Service Bulletin  
DSB-05182010

Re: Required Wiring Change to HVAC Units (all serial numbers).

The addition of a timer on the PCB for the HVAC is being implemented to units in the field.

**JUMPER**

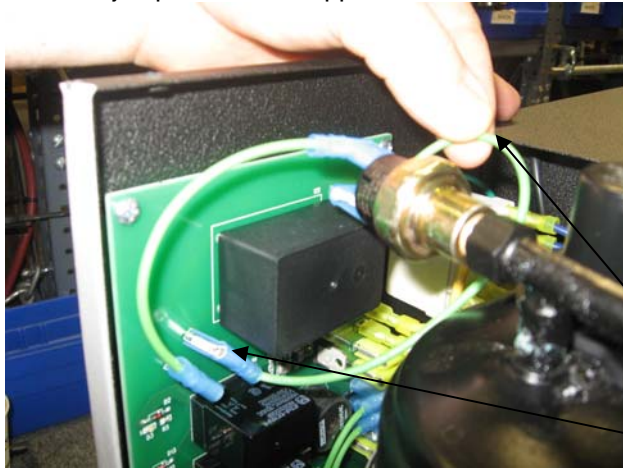
1. Remove compressor cover from HVAC box.
2. Remove jumper between upper PCB connector to high side pressure switch.

**Ground, Single, Double**

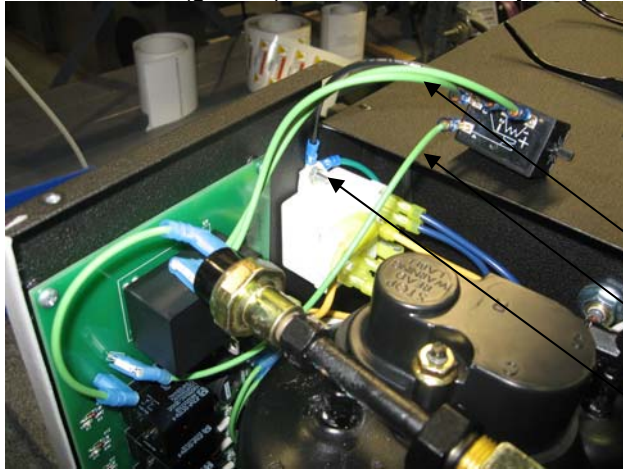
3. Connect green double-wire from time delay relay to high side pressure switch.
4. Connect green single wire from time delay to upper PCB connector.

5. Connect black (ground) wire from time delay relay onto screw behind potential relay.
